AMERICAN TOWER®
CORPORATION

TOWER REMEDIATION SCOPE OF WORK

ATC Site Number & Name	209106, Lee's Summit 2, MO
Tower Description	150-ft Monopole
Code	TIA-222-H
Site Location	900 Southwest Blue Parkway Lee's Summit, MO 64063 Jackson County 38.91020005, -94.39127213

Eng. Number	13350476_N3_01
Date	7/14/2021
Page	1 of 8
Reviewed by	IC
Priority	Yes
ATC TOWER SERVICES COA: 2015011232

Bid Item	3		
Deficiency Photo		Description of Work	As-Built Photo
		Additional photos provided for Bid Item 3. Please see description of work above.

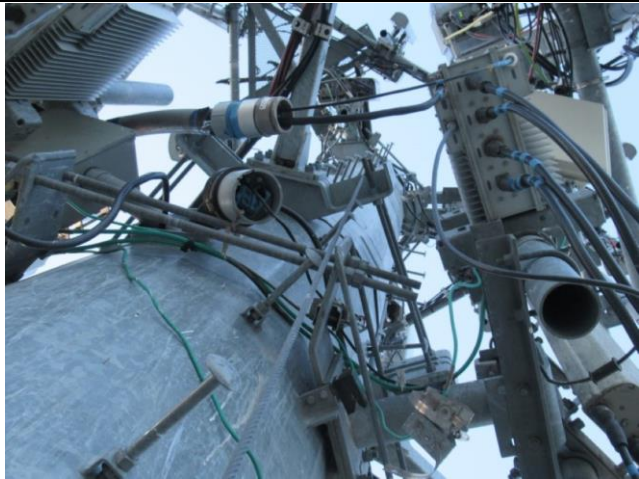
Bid Item	3		
Deficiency Photo		Description of Work	As-Built Photo
		Remove (2) existing step bolt bracket at 90', and 99', on Monopole. Install new AllFasteners NexGen2 blind-bolt assembly with step bolt adapter or ATC approved equivalent directly above existing step bolt bracket(s). New step bolts to be 5/8"Ø x 8" ASTM A449.
